# The X35 Official Firmware Release Note ( R0990 )

- ① Release date : August 30th, 2017
- ② The version of updated firmware : R0990
- ③ Refer to the below for the contents updated at R0990

### 2 Added one more service, Napster to Internet Service

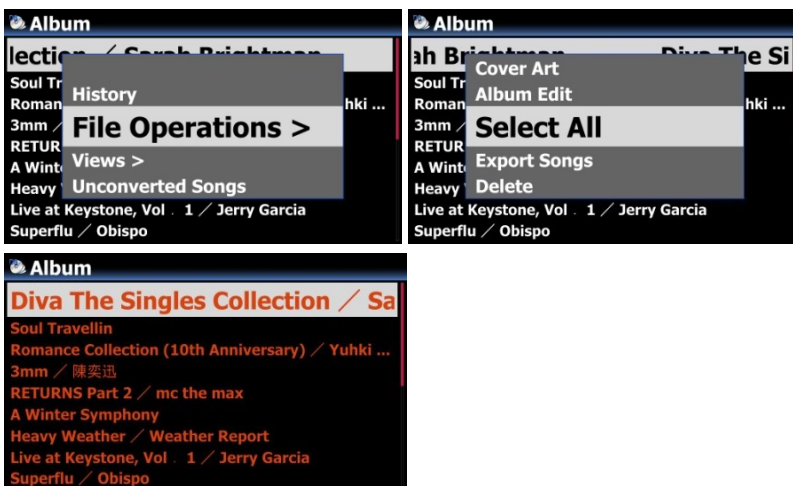
If you have ID for Napster, you can enjoy numerous songs at Napster with the X35 directly.
